**20-COA-0097**  
**1473 Saint James Ct.**

**Old Louisville Architectural Review Committee**  
**Public Hearing**

**Bradley Fister, Historic Preservation Specialist**  
**July 29, 2020**

# Request

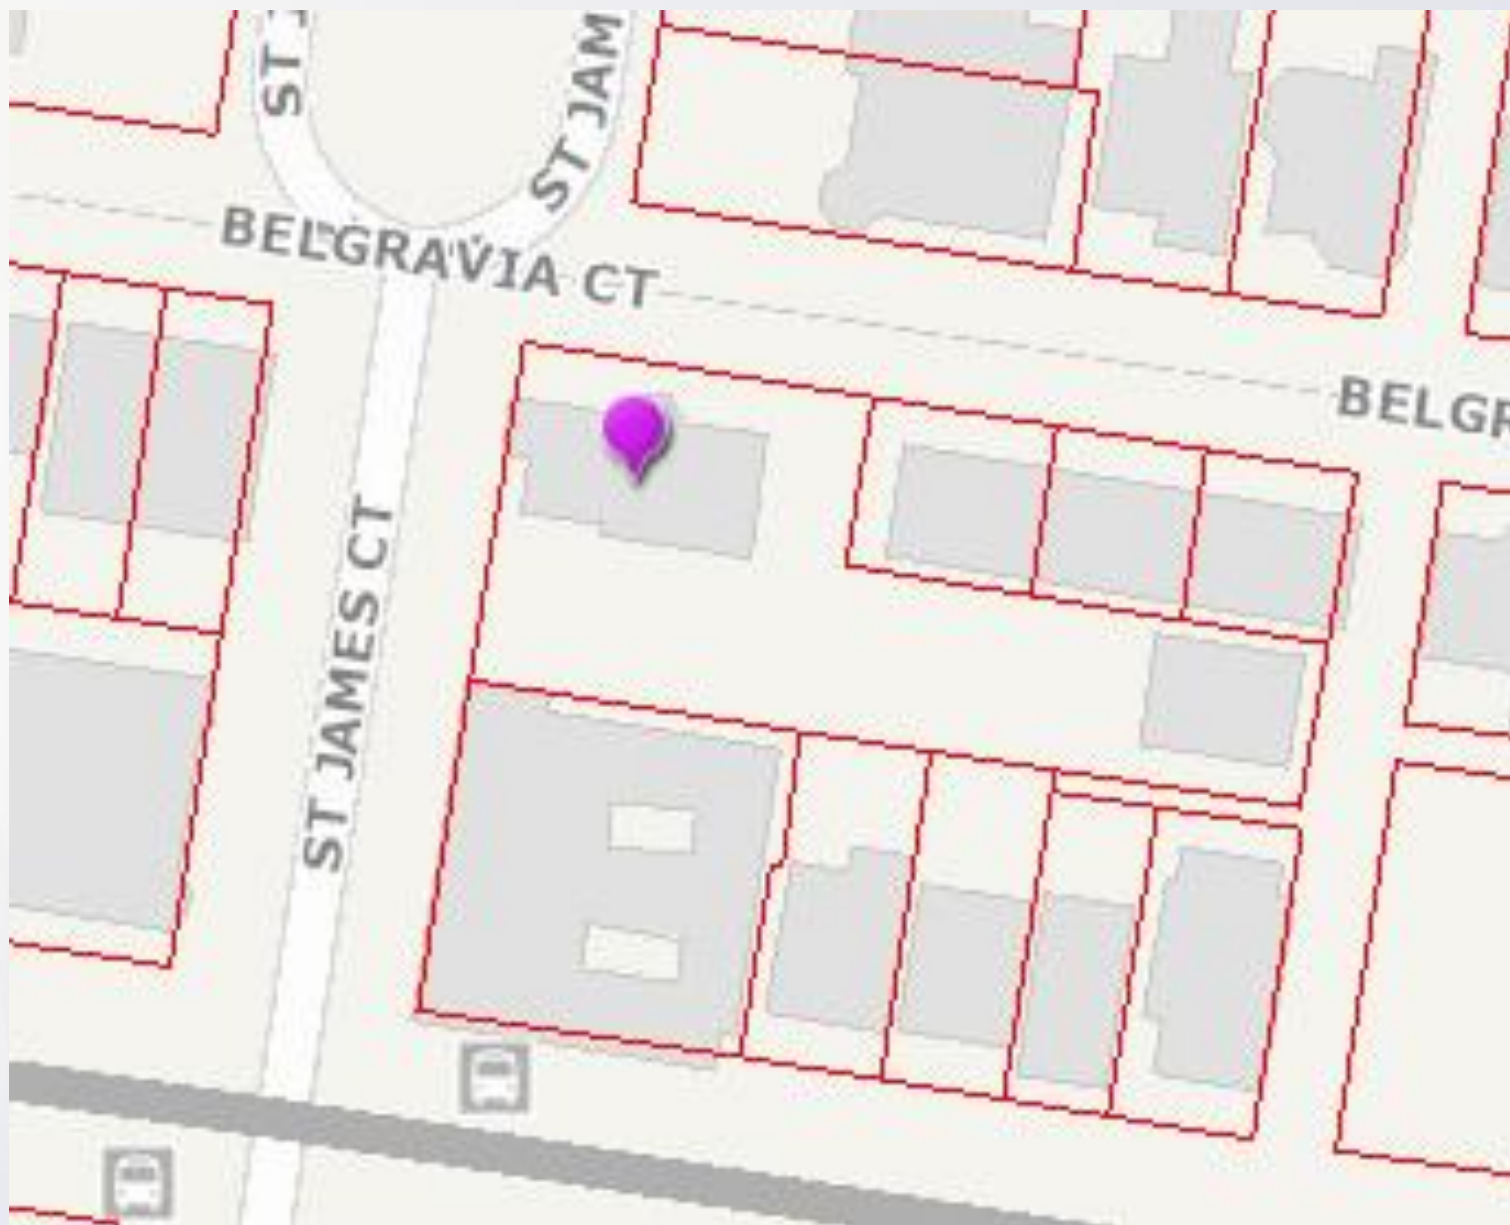
At this time the applicant proposes to also replace the cracked limestone steps on the front of the home and then flank them with 1'-6" x 1'-6" brick columns approximately 2' in height that will be capped with bronze urns. All brick shall be painted to match the existing colors of the home. The applicant also proposes to cap the current purple portion of the turret with copper, and add a peacock weathervane.

**2. The replacement of the cracked limestone stair shall be with the same material and the choice of stone presented to staff for approval prior to removal of existing stair.**

**3. The painting of the proposed new masonry construction shall not be the same color as the home in order to distinguish between what is historic and what is not, and the color shall be presented to staff prior to painting for approval.**
